## AGENDA - LPP

<b>Meeting:</b>	Georges River Local Planning Panel (LPP)
<b>Date:</b>	Thursday, 10 December 2020
<b>Time:</b>	4.00pm
<b>Venue:</b>	Council Chambers, Civic Centre, Hurstville
<b>Panel Members:</b>	Paul Vergotis (Chairperson) John Brockhoff (Expert Panel Member) Michael Leavey (Expert Panel Member) Annette Ruhotas (Community Representative)

# REPORT TO GEORGES RIVER COUNCIL LPP MEETING OF THURSDAY, 10 DECEMBER 2020

<b>LPP Report No</b>	<b>LPP063-20</b>	<b>Development Application No</b>	<b>DA2020/0261</b>
<b>Site Address &amp; Ward Locality</b>	15 Dalcassia Street Hurstville Hurstville Ward		
<b>Proposed Development</b>	Demolition of existing and construction of boarding house		
<b>Owners</b>	Citywide Pty Ltd		
<b>Applicant</b>	Cracknell and Longergan Architects Pty Ltd		
<b>Planner/Architect</b>	Architect: Cracknell and Longergan Architects Pty Ltd, Planner: Cracknell and Longergan Architects Pty Ltd		
<b>Date Of Lodgement</b>	30/06/2020		
<b>Submissions</b>	Seven (7) submissions		
<b>Cost of Works</b>	\$2,300,000.00		
<b>Local Planning Panel Criteria</b>	Council Delegations for Local Planning Panel Determinations		
<b>List of all relevant s.4.15 matters (formerly

Figure 1: Extract of proposed basement level (Source: Cracknell Lonergan Architects, 2020).

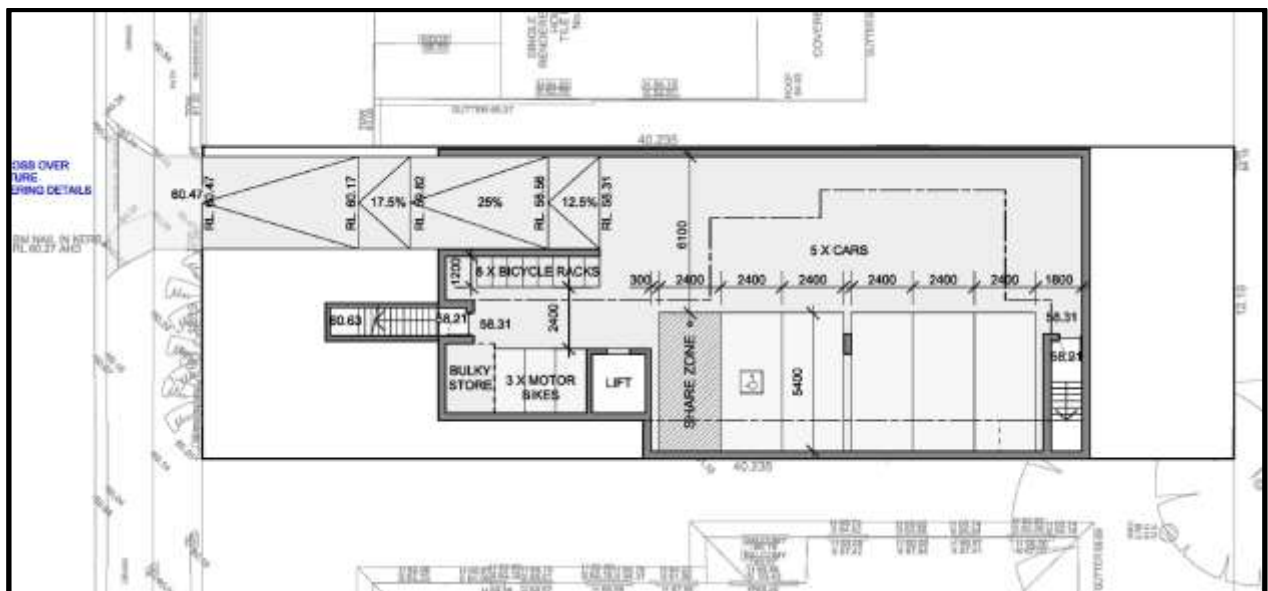
5. The proposal is not considered to satisfy State Environmental Planning Policy Affordable Rental Housing (2009) and does not comply with the minimum number of car parking required, being seven (7). Five (5) car spaces are proposed on site. Whilst the provisions of the SEPP prevails over the Hurstville Development Control Plan regarding minimum car parking requirements, it is noted that Council’s controls would require ten (10) car spaces.

**Figure 2:** Extract of ground floor indicating the location of the proposed communal open space within front setback (Source: Cracknell Lonergan Architects, 2020).

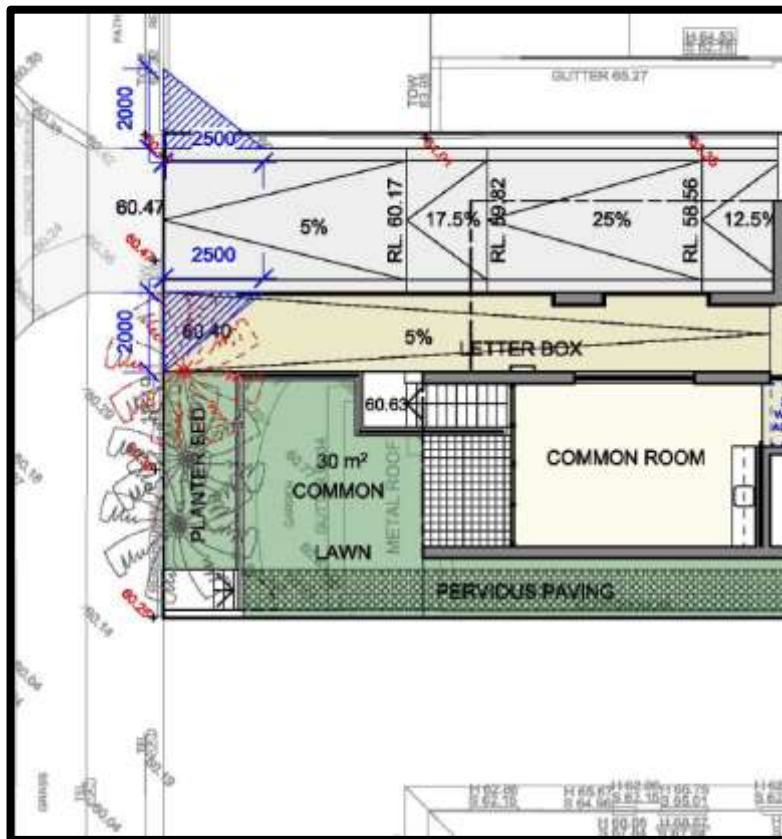
6. The design proposes a majority of the communal open space (13sqm of the 20sqm required) within the front setback which is contrary to the SEPP and inconsistent with the local character of the area.

**Figure 3:** Extract of section of subject site in relation to adjoining properties (Source: Cracknell Lonergan Architects, 2020).

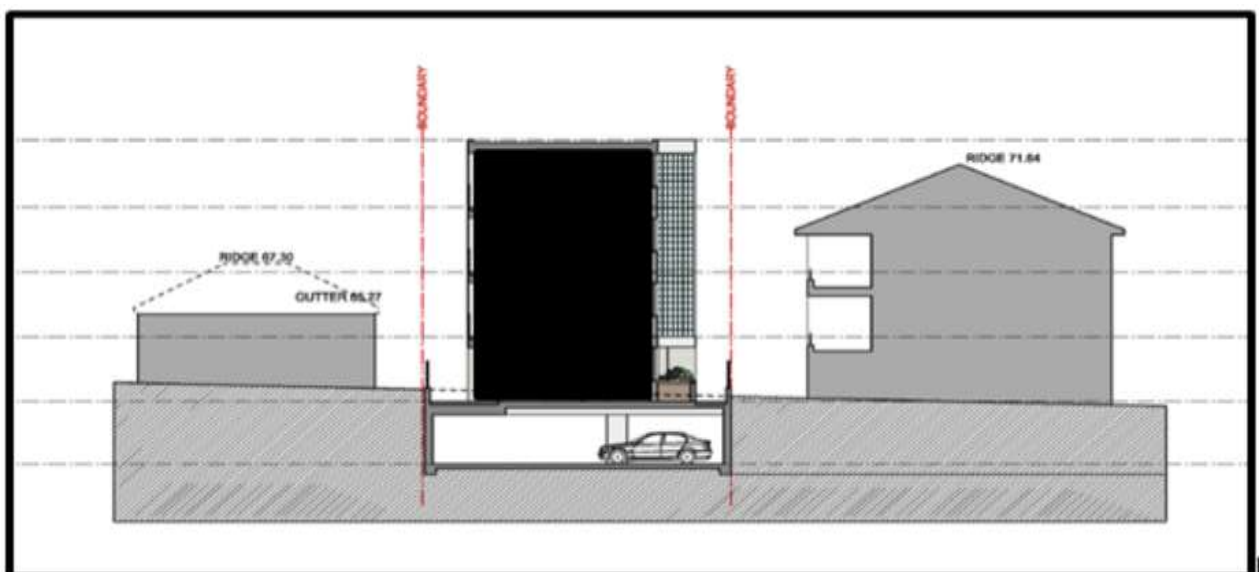
7. The proposal fails to satisfy Clause 30A Character of the area given the proposed form and proportion of the development results in limited spatial separation to adjoining properties. The proposal adopts a building typology with a scale and form of a four (4) storey residential flat building, with a 1.6m side setback for all four (4) levels. The established character of the locality is residential flat buildings with pitched roofs surrounded by landscaped areas, with proportionate spatial separation and lot width. Established dwelling houses are located on allotments of similar widths and size to that of the subject site. (*\*Note: the proposed rear setback of the boarding houses aligns with 17 Dalcassia Street (side) at 6m from the rear boundary.*)

**Figure 4:** Extract of cross section indicating breach of lift overrun over 12m, no RL for the lift overrun has been provided (Source: Cracknell Lonergan Architects, 2020).

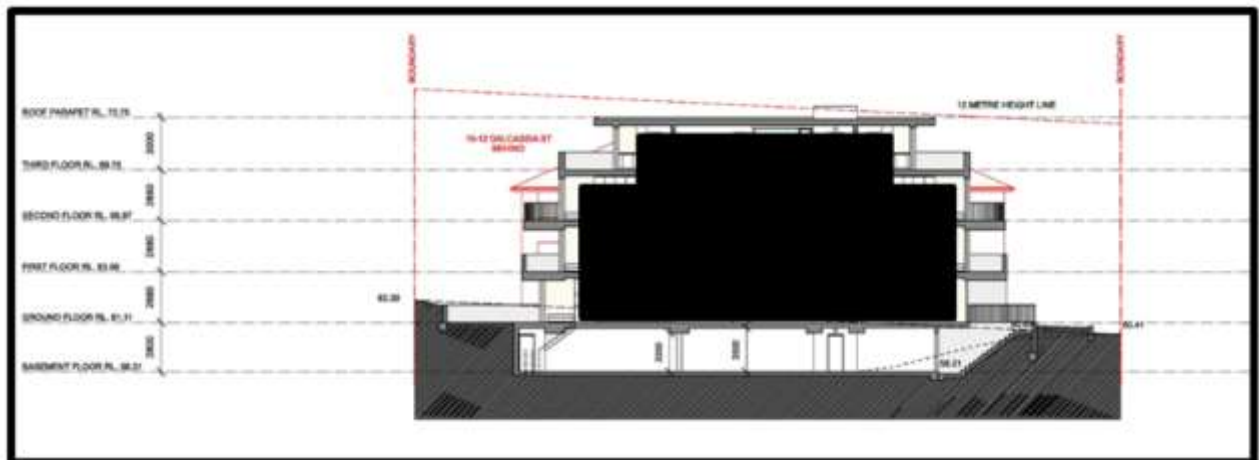
8. Clause 4.3 of the Hurstville Local Environmental Plan 2012 prescribes a height of building control of 12m. A lift overrun has been shown on the section below, however this has not been shown any of the external elevations.

**Figure 5:** Extract roof plan indicating a lift overrun with no nominated RL (Source: Cracknell Lonergan Architects, 2020).

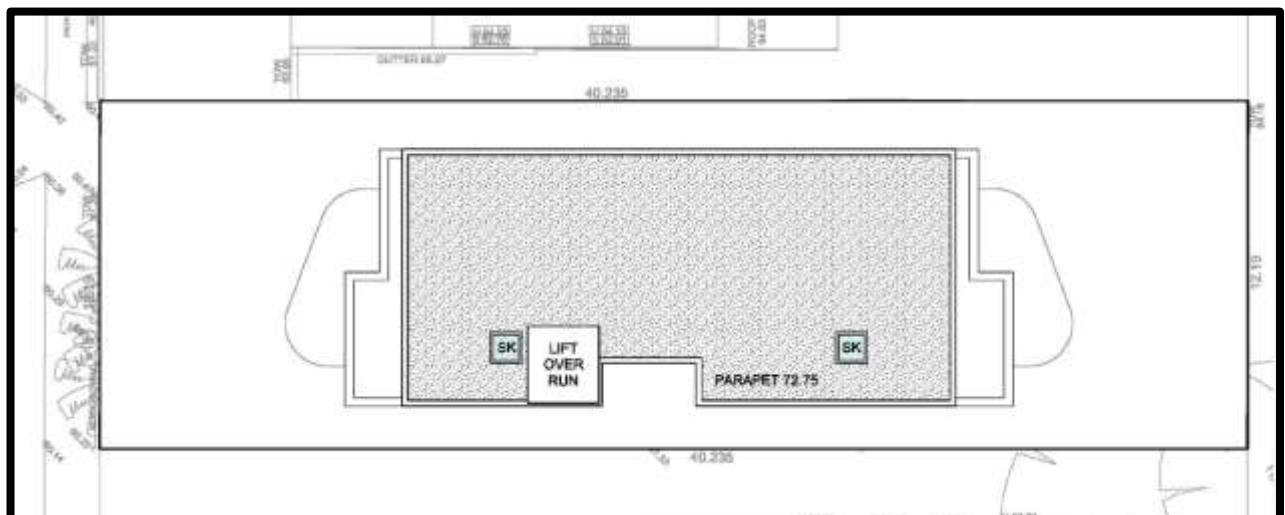
9. Based on the section and scaled dimensions submitted, Council's assessment indicates that the proposal seeks a height of building in excess of 12m to accommodate the lift overrun at 12.6m.
10. A Clause 4.6 Exception to Development Standard is required to consider a variation to a Development Standard. A Clause 4.6 Exception to Development Standard has not been provided in support of this height breach.

**Figure 6:** Extract of part of unit layout on levels 1, 2 and 3 with poor aspect and outlook (Source: Cracknell Lonergan Architects, 2020).

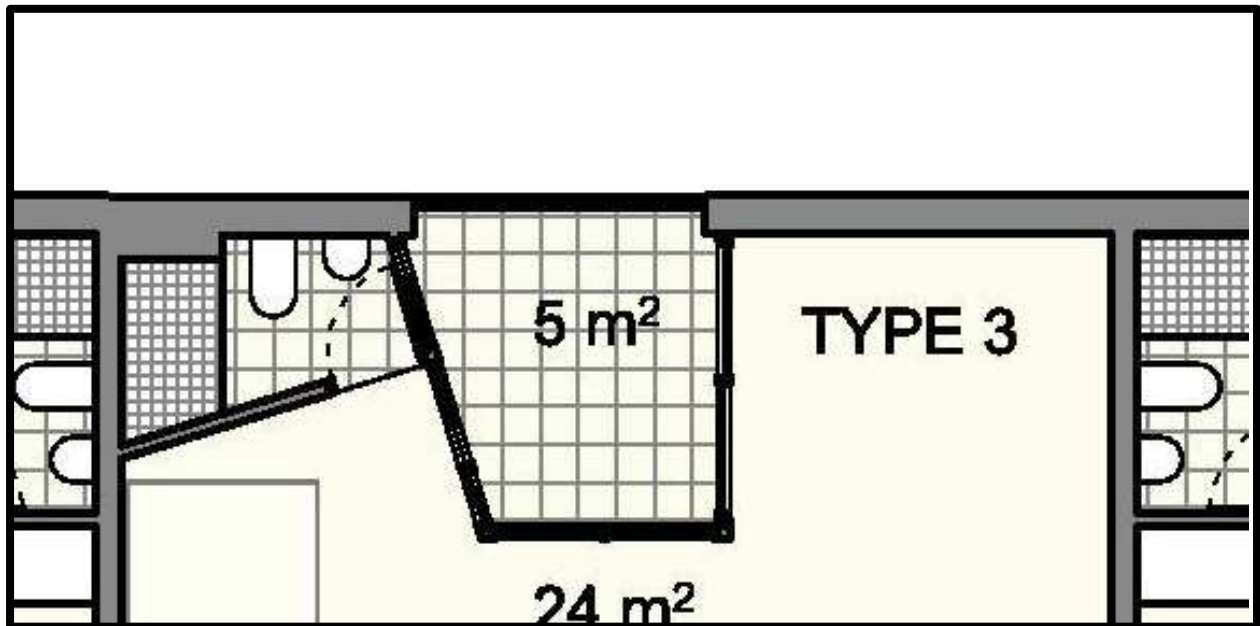
12. The proposal fails to comply with the following subsections of the Hurstville Development Control Plan No. 1.
  - Section 3.3 – Access and Mobility
  - Section 3.9 – Waste Management
  - Appendix 1 – Indicative Number of Storeys
13. The proposal results in adverse impacts in relation to occupant and neighbouring amenity whereby rooms (103, 203 and 302) on levels 1, 2 and 3 have a poor aspect and outlook as they are generally orientated internally as their windows which directly face side boundary are frosted.

**Figure 11** The proposal seeks 13sqm of communal open space forward of the building line which results in poor amenity and detracts from the usability of this space (Source: Cracknell Loneragan Architects, 2020).

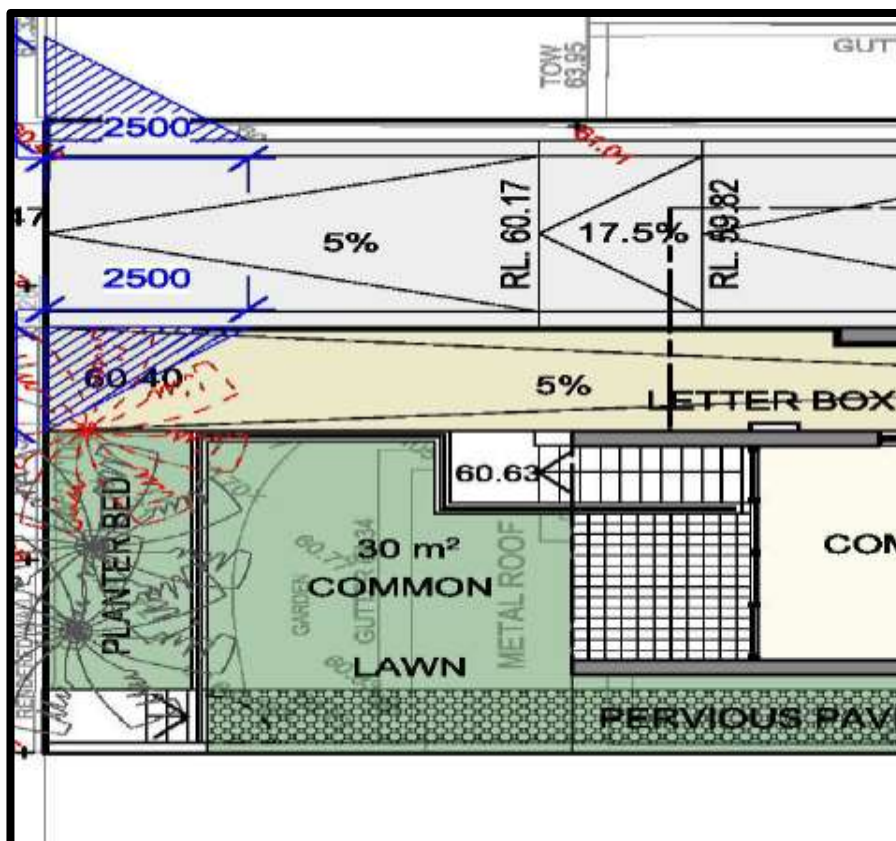
The proposal provides only 7sqm which does not comply with the SEPP. The proposal provides the majority of communal private open space for lodgers of the boarding house located within the front setback forward of the building line. This is not considered to be appropriate and results in limited privacy and amenity which is considered to detract of the use of this space providing poor recreation areas for future occupants.

**Figure 6:** Proposed height of building at RL53.55 (13.66m)

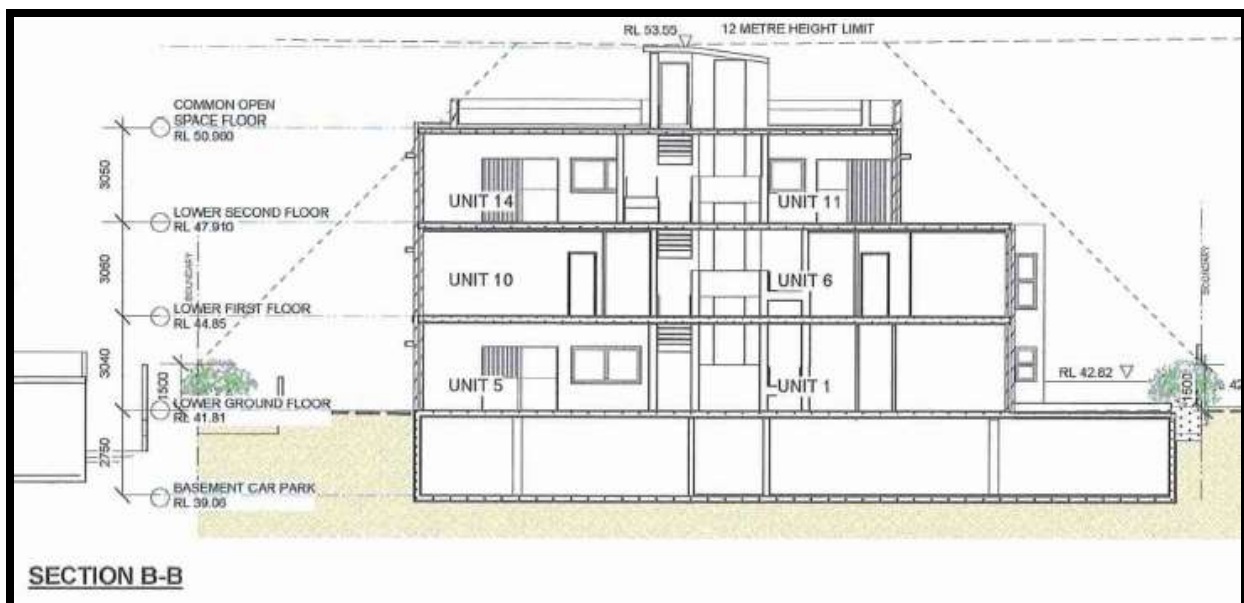
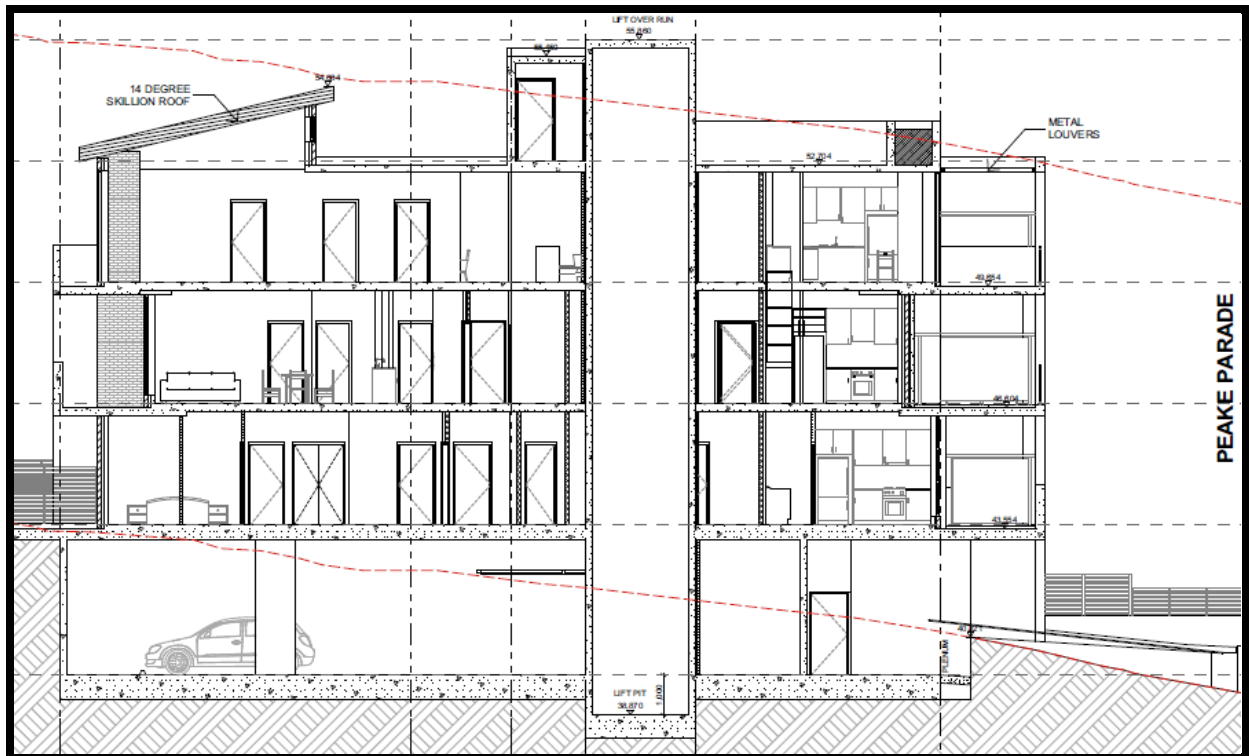
65. The height of the development has increased as part of the modification, resulting in a variation to the maximum height of buildings control of 12m. The proposed lift overrun reaches a height of 13.66m, a variation to the standard of 13.8%, and this variation has been assessed below.
66. The approved height of the development is 12m. The increase in height is a result of the levelling of the floor plates, which were approved with split levels, and to address the overland flow affection of the site.
